Re: Notice to Contest Yellow Creek Instream Flow Appropriations

NOTICE TO CONTEST INSTREAM FLOW APPROPRIATIONS

RE: CWCB ISF Recommendations, Yellow Creek (Upper) and Yellow Creek (Lower)

**Figure 2: Yellow Creek (Upper)
ISF Claim**

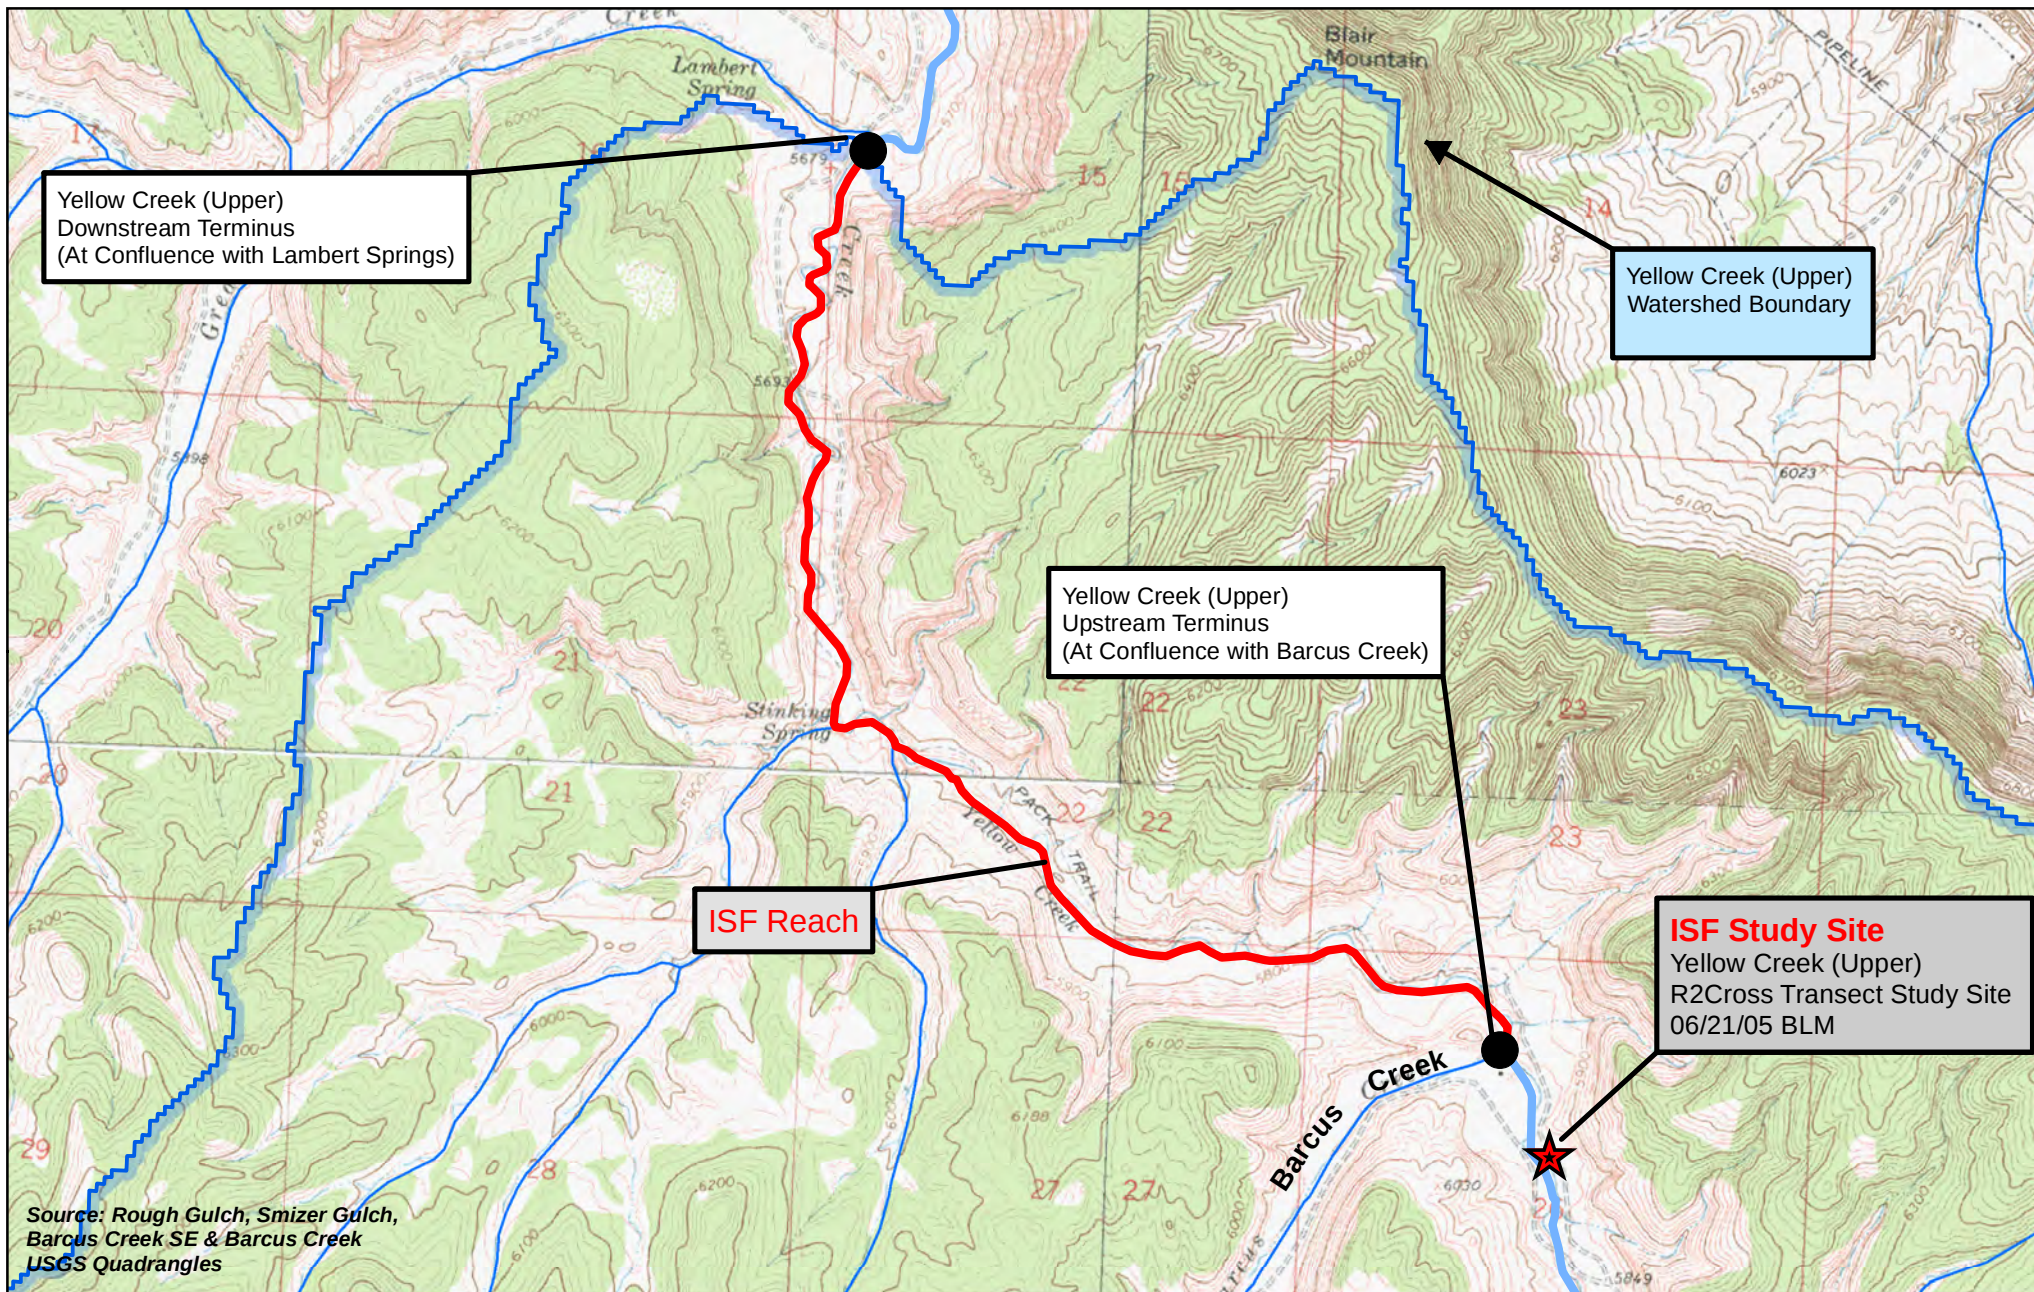
The problem with this recommendation, however, is that the only study transect used to quantify the summer ISF is not located within the defined Yellow Creek (Upper) ISF reach. Rather, it is located approximately 1/3 mile upstream of the confluence of Yellow Creek and Barcus Creek, the upper terminus of the claimed ISF reach. Although the submitted R2Cross data sheets label the location of the study transect as; “1,800 feet d/s from conf. w/Barcus Creek” (within the study reach), we believe this description to be in error. Review of the original field notes which include both a written description and an associated latitude and longitude that place the study site upstream of the Barcus Creek confluence. Accordingly, the data collected and relied upon by the agencies to quantify the summer ISF is not representative of the Yellow Creek (upper) ISF reach and therefore, should be disregarded. This leaves no viable data to support a summer ISF within this reach. The location of the BLM/CWCB study site in relationship to the upper ISF reach is shown in **Figure 2**.

Attachment 1

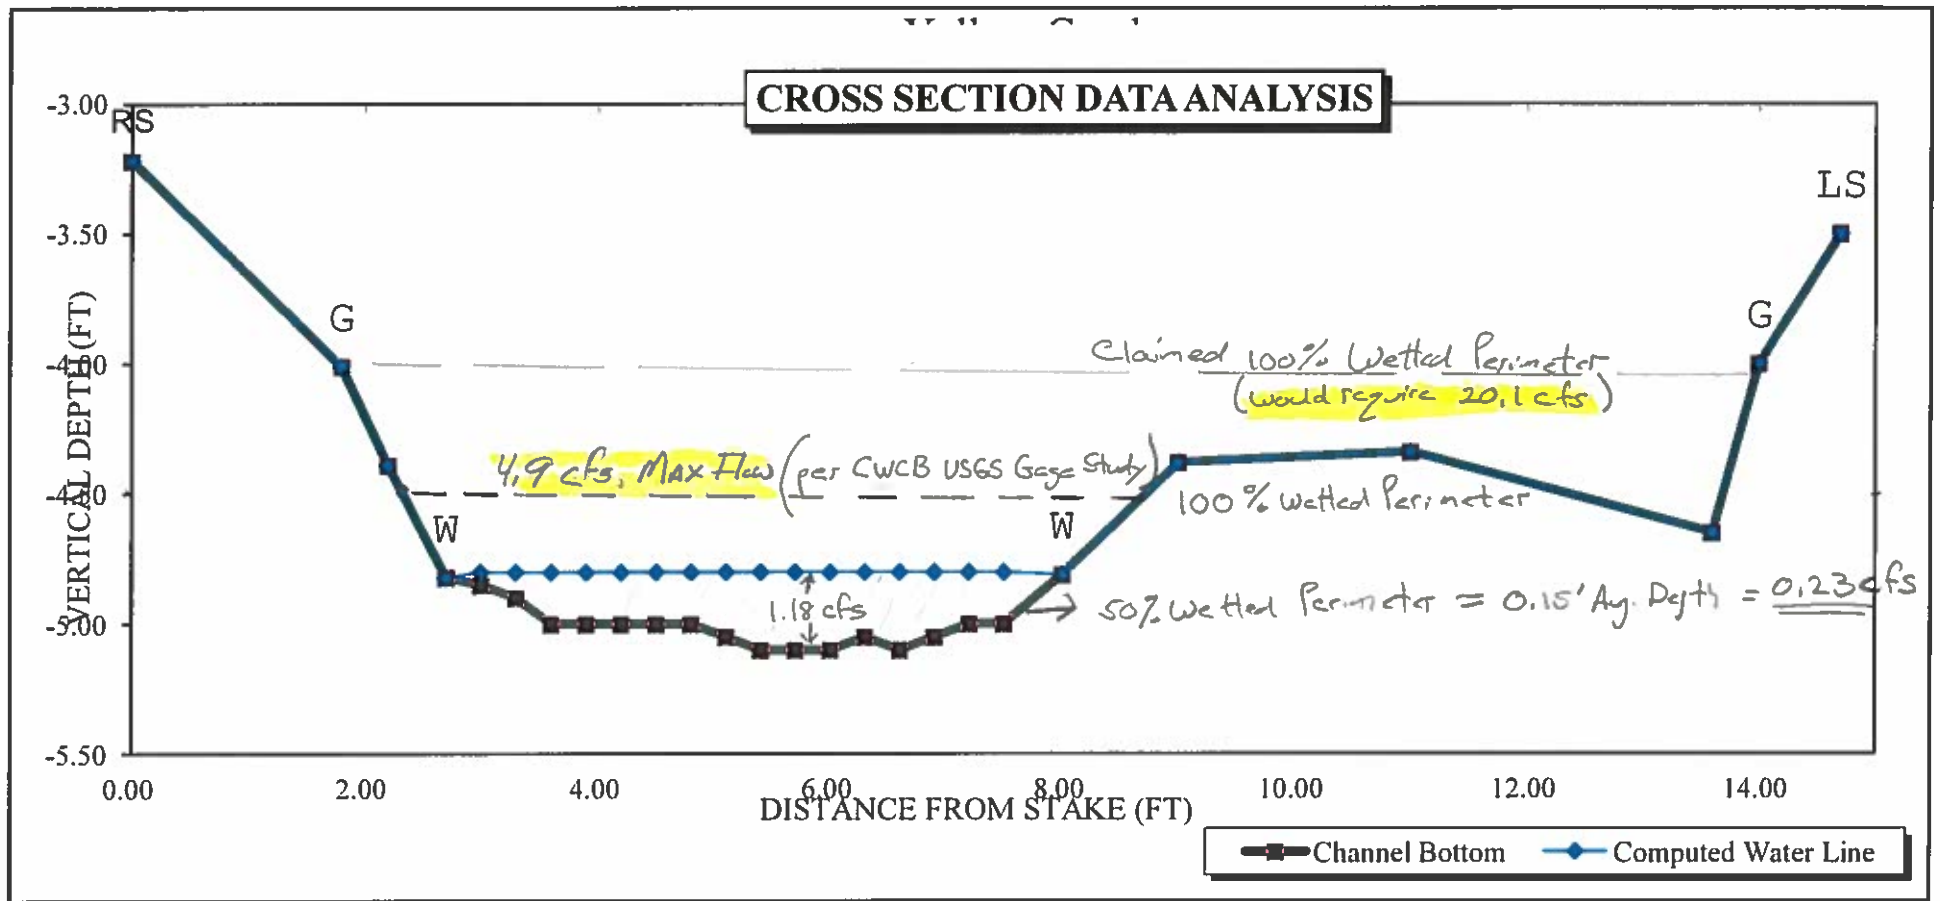
In evaluation of the BLM/CWCB supporting data, however, it is apparent that the investigators have erred in their application of the R2Cross methodology. In quantification of a summer ISF, one of the three hydraulic characteristics that must be met includes a streamflow capable of inundating 50% of the defined wetted perimeter. A 100% wetted perimeter would be that length of channel cross section as measured from the grassline of one streambank to the grassline of the opposite streambank and thus, is representative of bank full conditions that occur during seasonally high streamflows. The ISF streamflow selection criteria would be satisfied at a depth of water that would cover 50% of this defined high flow channel length (cross section length). In this study, it appears that the 100% bankfull width was not correctly identified in either study transect and therefore, the assumed flow that would occur at the 50% wetted perimeter is not correct. In one of two of the study transects, the error results in a significant overestimate of the streamflow necessary to satisfy the 50% criteria. As a result, the claimed ISF is not representative of the minimum amount of water necessary to preserve the natural environment to a reasonable degree.

Attachment 1 and **Attachment 2** show the channel cross sections of the two study sites as contained in the agencies referenced materials. Hand notes have been placed on the cross sections by RESOURCE to display the water elevation and corresponding streamflow that would occur at the 100% wetted perimeter that was identified by the BLM/CWCB. **Attachment 1** represents the study transect that was evaluated with a corresponding measured streamflow of 1.19 cfs. At the 100% wetted perimeter identified by the investigators, the streamflow of Yellow Creek would have to be at a flow of 20.1 cfs. The CWCB's water availability analysis contained in the executive summary, however, shows that maximum streamflow occurring at this site is approximately 4.9 cfs (**Attachment 3**). The daily streamflow summary was based upon review of a nearby USGS streamflow gage. The measured data indicates that the 100% wetted perimeter should have been placed at an elevation in the cross section closer to streamflow conditions at 5 cfs, not 20 cfs. The resulting error is significant. The BLM/CWCB staff conclude that the 50% wetted perimeter criteria would be met at a flow of 3.31 cfs when in fact, it appears that the criteria is met at flows of approximately 0.2 cfs. The reason that the criteria can be met at lower flows is attributed to the characteristics of the channel within the lower reach. Both transects have a high width/depth ratio. A similar mistake was made with respect to the second transect that was studied at a flow rate of 1.04 cfs. The defined 100% wetted perimeter would require streamflows of approximately 17 cfs (**Attachment 2**). If the 100% wetted perimeter was properly located at an elevation supporting a flow of approximately 5 cfs (bank full), the wetted perimeter criteria would be satisfied at a lower streamflow. Due to these apparent errors, the summer ISF recommendation the Yellow Creek (lower) reach appears to be significantly over stated.
